Subject: Issuance of Amendment No. 28 to Facility Operating
License NPF-21 - WPPSS Nuclear Project No. 2

This amendment revises the WNP-2 Technical Specifications to support the operation of WNP-2 at full rated power during the next fuel cycle, Cycle 2. This reload amendment changes the Technical Specifications in the following areas: (1) establishes operating limits for all fuel types for the upcoming Cycle 2 operation; (2) reflects the replacement of 128 initial core fuel assemblies with Exxon Nuclear Company (ENC) fuel assemblies. Also included are related modifications of the Bases section of the Technical Specification to account for the use of Exxon fuel assemblies.

Amendment No. 28
License No. NPF-21

ENCLOSURE TO LICENSE AMENDMENT NO. 28

Figure 3.2.1-1

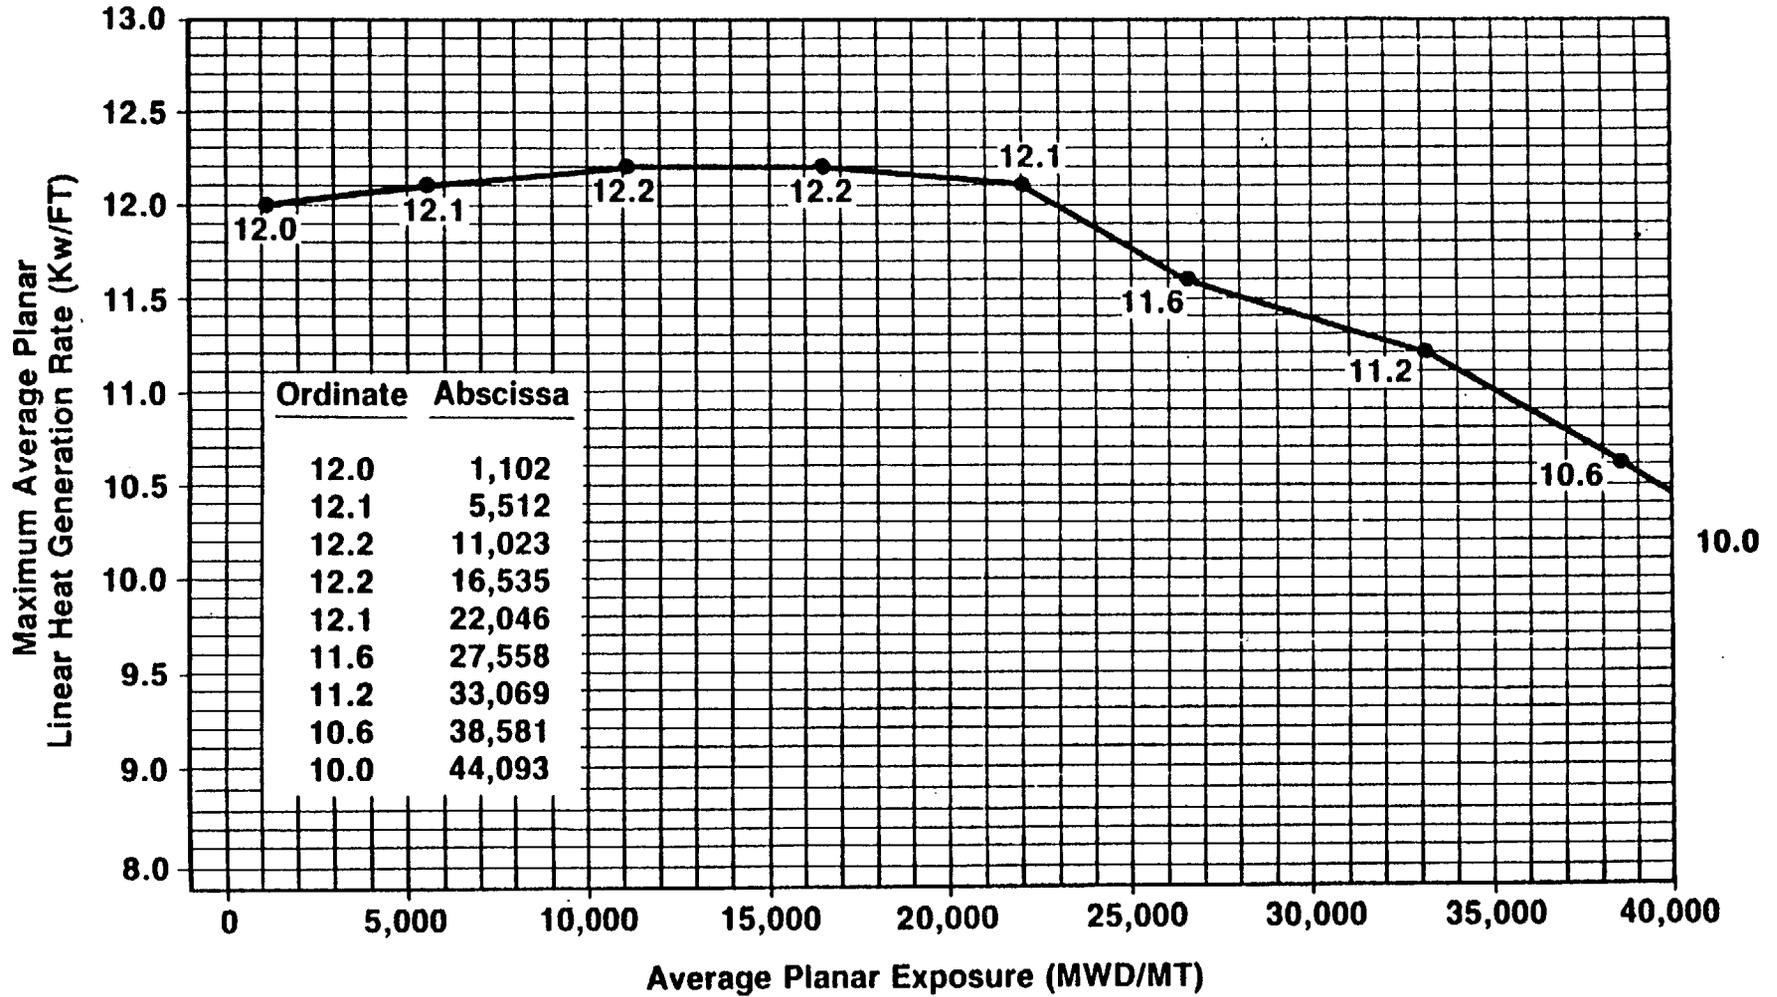
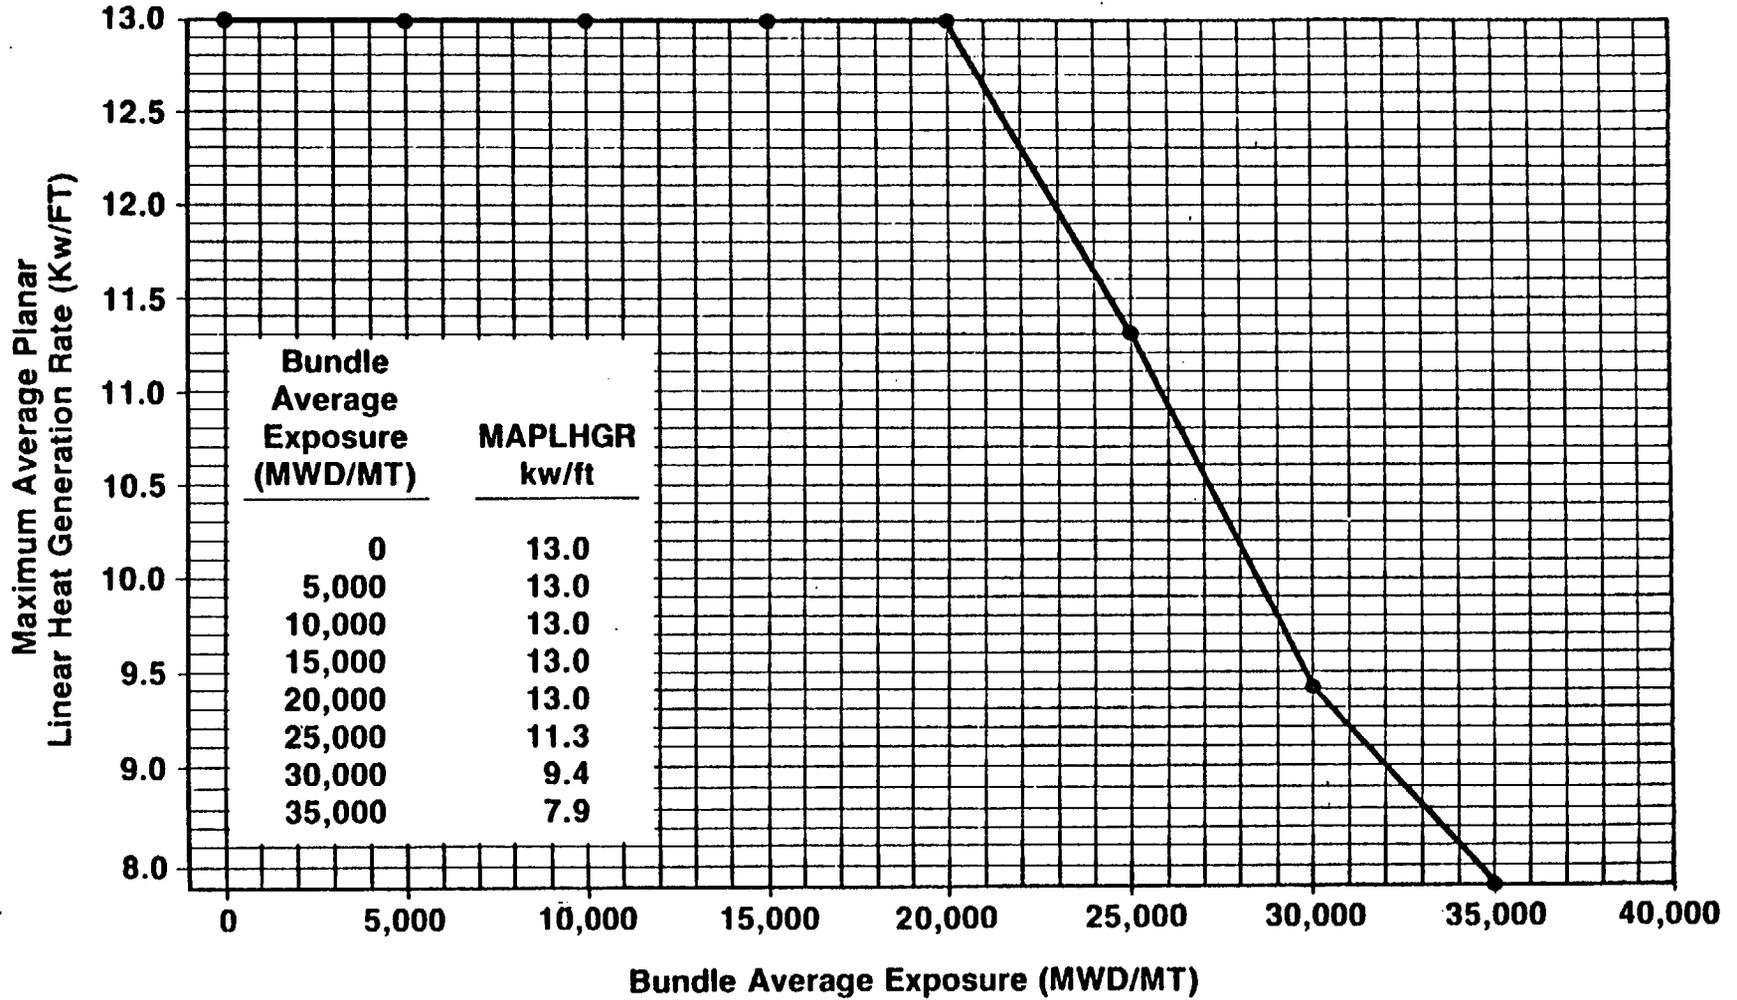
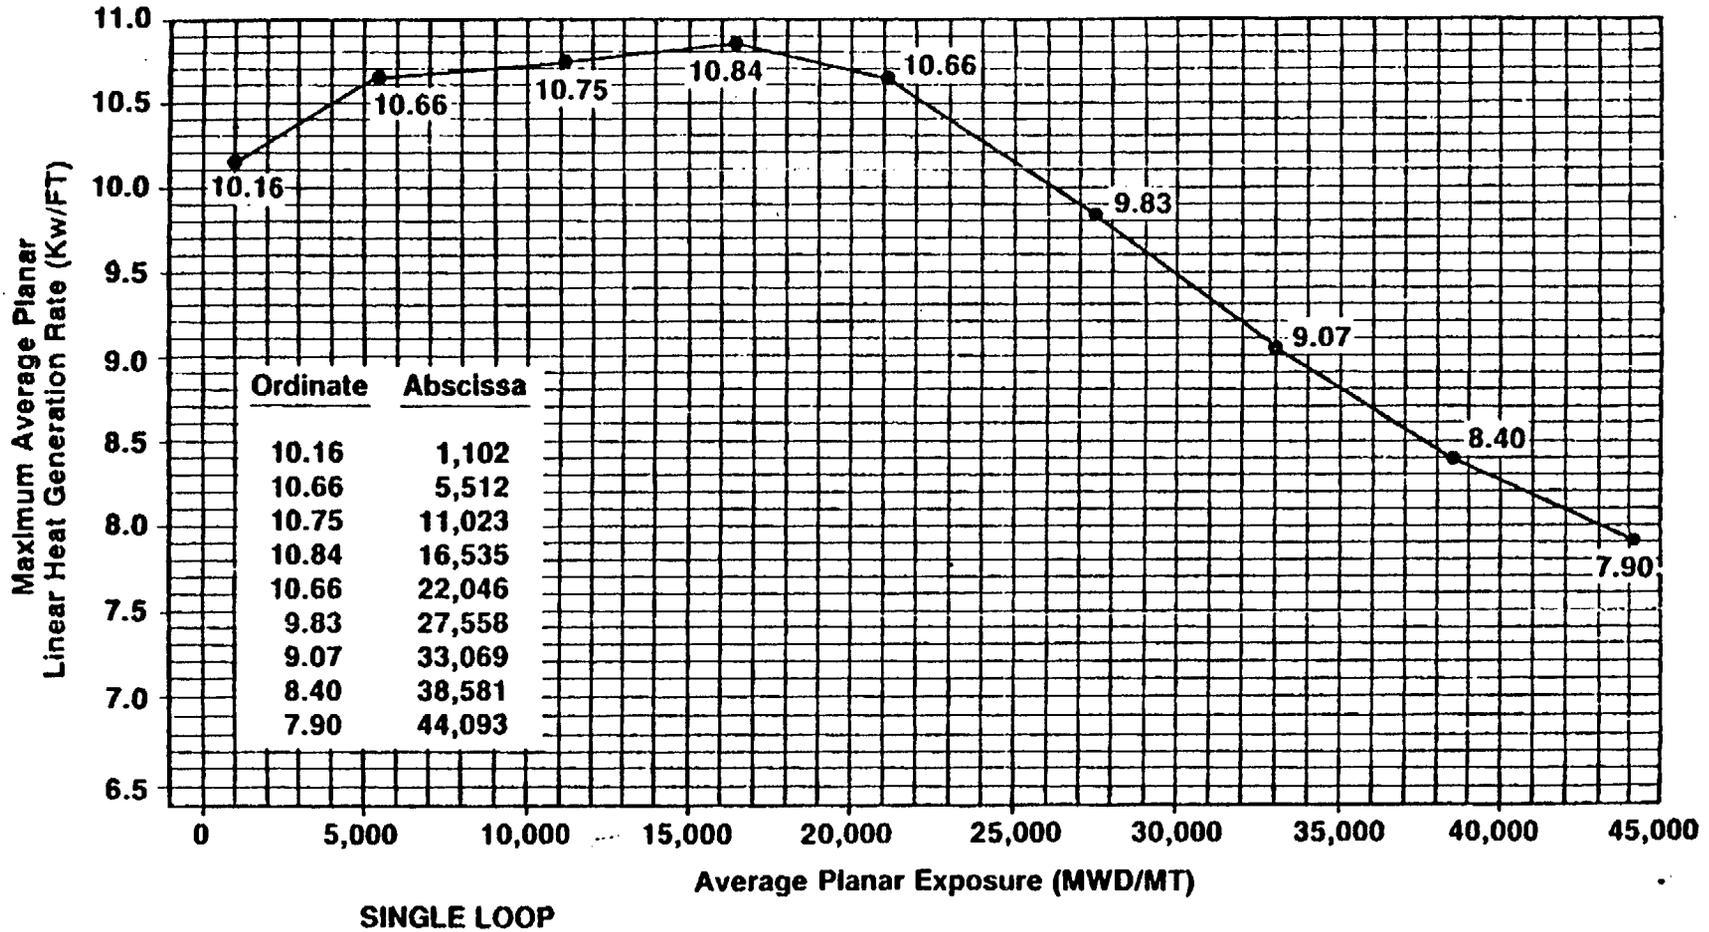
- (4) 3.2.1, and Figures 3.2.1-1 through 3: This is a change to the use of the Exxon definition of Average Bundle Exposure for Exxon fuel and the transfer to metric units for GE fuel burnup. A MAPLHGR curve is added for the XN-1 fuel and the curve for unused low enrichment GE fuel is removed. These are acceptable changes.

3.2.1 All AVERAGE PLANAR LINEAR HEAT GENERATION RATES (APLHGRs) for each type of fuel as a function of AVERAGE PLANAR EXPOSURE for GE fuel and average bundle exposure for ENC fuel shall not exceed the limits shown in Figures 3.2.1-1, 3.2.1-2, and 3.2.1-3. The limits for single loop operation are shown in Figures 3.2.1-4, 3.2.1-5, and 3.2.1-6.

With an APLHGR exceeding the limits of Figure 3.2.1-1, 3.2.1-2, or 3.2.1-3, initiate corrective action within 15 minutes and restore APLHGR to within the required limits within 2 hours or reduce THERMAL POWER to less than 25% of RATED THERMAL POWER within the next 4 hours.

Figure 3.2.3-1

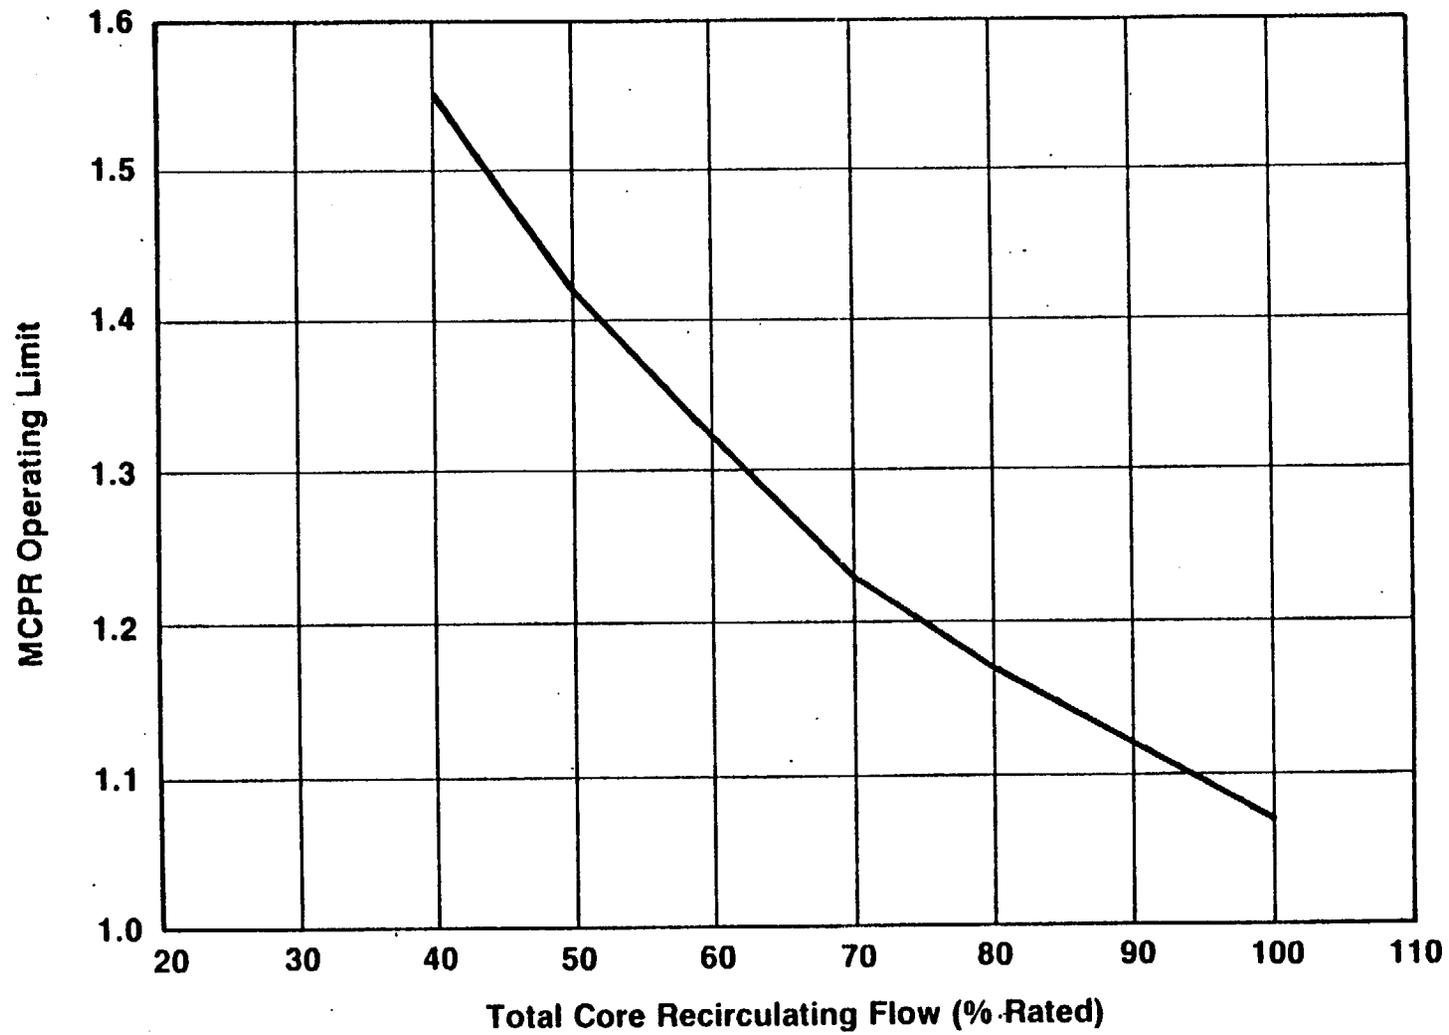
- (5) 3/4.2.3 plus Table 3.2.3-1 plus Figure 3.2.3-1: This change removes the elements of the GE methodology for determining MCPR limits, including the K_f function, and replaces them with the results of the Exxon methodology and analyses for N2C2. The new MCPR limits are principally single value functions of (1) GE or Exxon fuel, (2) Scram time, (3) RPT operability and (4) Core flow. MCPR is limited, for reduced flow operation, as given in the figure. As previously discussed these values are the results of Exxon's calculations of transients and are primarily controlled by the RWE and LRWB. The values to be used for Table 3.2.3-1 are not those of the original submittal, but those of Reference 7 from analyses using the revised loading parameters. "Normal" scram time is defined in this specification, including the time to standard notches and surveillance is referenced to the existing surveillance specification of 4.1.3.1. These changes are acceptable.

The purpose of the $MCPR_f$ of Figure 3.2.3-1 is to define operating limits at other than rated core flow conditions. At less than 100% of rated flow the required MCPR is the maximum of the rated flow MCPR determined from Table 3.2.3-1 and the reduced flow MCPR determined from Figure 3.2.3-1, $MCPR_f$ assures that the Safety Limit MCPR will not be violated. $MCPR_f$ is only calculated for the manual flow control mode. Automatic flow control operation is not permitted.

Figure 3.2.4-1

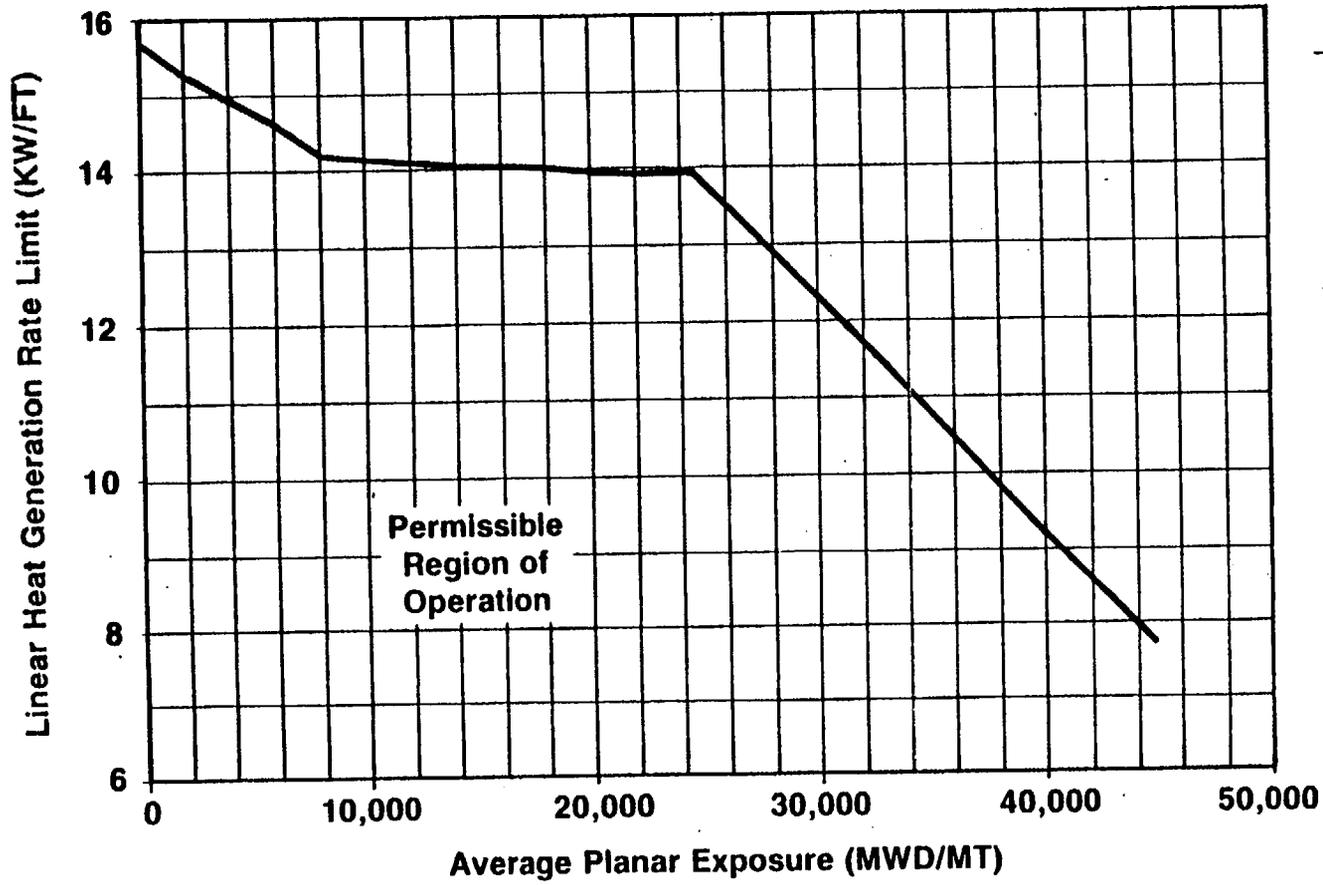
- (6) 3.2.4 and Figure 3.2.4-1: A LHGR for the Exxon XN-1 fuel is added to this specification. As was previously discussed, this type of specification and figure giving LHGR as a function of burnup was added to the Susquehanna 1 specification as a result of staff discussions with Exxon. This addition to the WNP-2 specification is also acceptable.

3.2.4 The LINEAR HEAT GENERATION RATE (LHGR) for GE fuel shall not exceed 13.4 kW/ft. The LHGR for ENC fuel shall not exceed the values shown in Figure 3.2.4-1.
